MINERALS PROGRAM INSPECTION REPORT**PHONE: (303) 866-3567**

MINE NAME: Westhoff Pit	MINE/PROSPECTING ID#: M-1977-094	MINERAL: Sand and gravel	COUNTY: Morgan
INSPECTION TYPE: Monitoring	INSPECTOR(S): Jared L. Ebert	INSP. DATE: March 30, 2017	INSP. TIME: 09:30
OPERATOR: Morgan Sand & Gravel Inc	OPERATOR REPRESENTATIVE: Greg Westhoff	TYPE OF OPERATION: 112c - Construction Regular Operation

Westhoff Pit; M-1977-094

30 March 2017 Inspection

BOUNDARIES
STRAW BALES
SILT FENCE
Dam

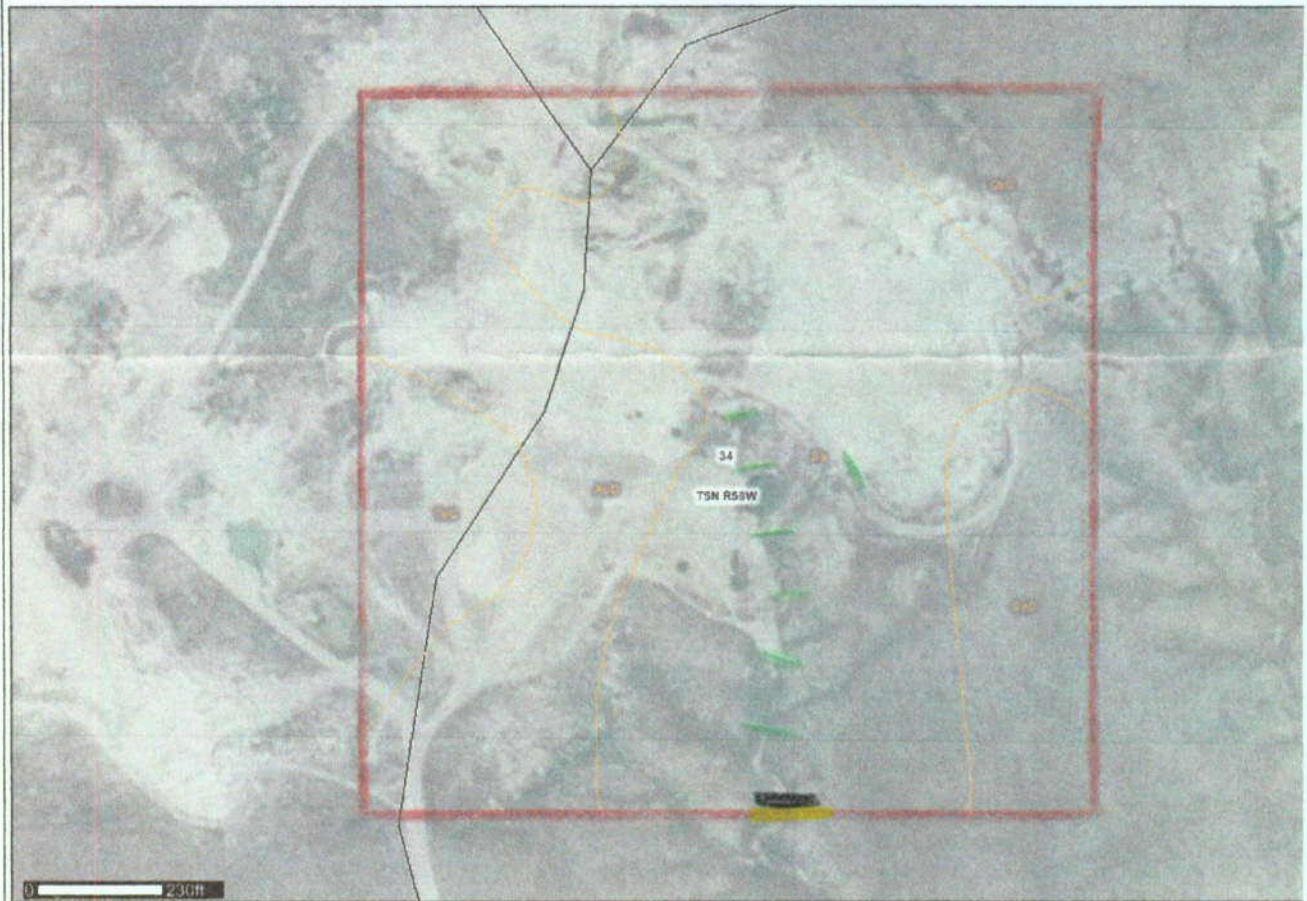
This letter is to answer all of the questions that you or the board has regarding the earth dam.

- (d) Map is attached where the dam will be built.
- (e) To help with wind erosion the top of the dam will be seeded. Also the backside of The dam will be seeded to help with erosion from wind and rainfall.

- (a) The inline Water level control structure will be used that way water will flow out of the dam as the level reaches a level of (3 feet). This would also control the rate at which the water would be discharged out of the dam.

- (b) The height of the dam has been lowered to (ten feet). The length will be (75 feet) from The East side to West side. The width at the top of dam will be (12 feet). The base of the dam will be (25 feet). The total volume of material to build the dam should be around 685 yards. Morgan Sand & Gravel will remove the dam when it needs to be taken out.

- (f) Aprons (Spillways) will be placed on both sides of the dam. That way when we have a heavy rain, if the Water Control Structure cannot keep up water can discharge out the Spillways. Each Spillway will be (8 feet) wide (12) feet Long. Riprap will be placed in each Spillway. Riprap will be concrete that will come from Morgan Sand & Gravel's Recycle yard.
